FCT SERVICE NOTE SN06101010A

Subject: IG, VIG, DARC2, VDARC Computer

Effectivity: LightSpeed 1x, 2x, 3x, 4x, 5x, 7x and HighSpeed QX/I GRE Host Console

Westville – Jarrell Physical Differences / Pictures

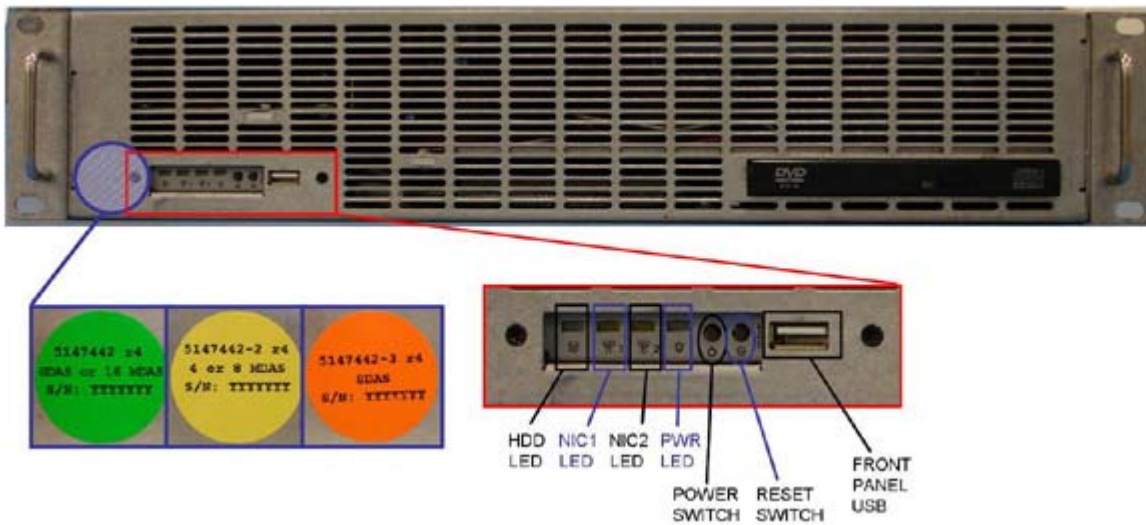
Westville DARC Picture -- Front

Jarrell DARC Picture -- Front

Westville IG -- Front

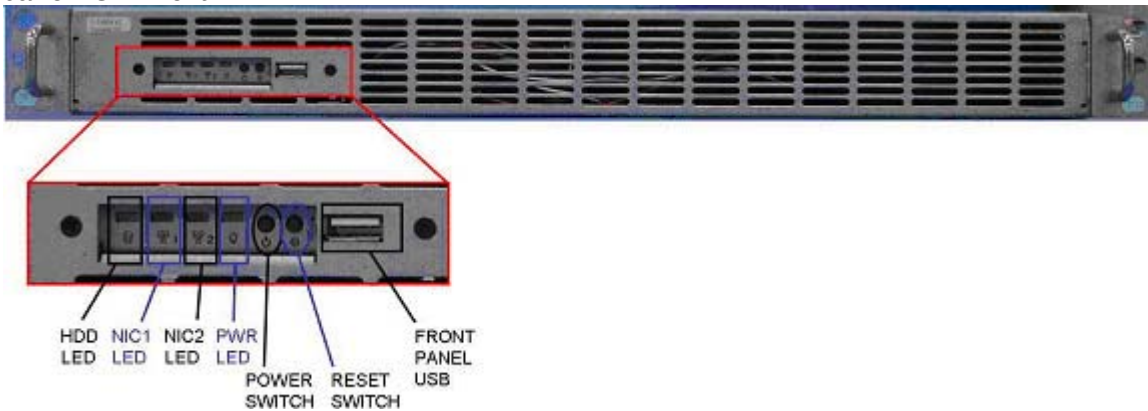
Jarrell IG -- Front
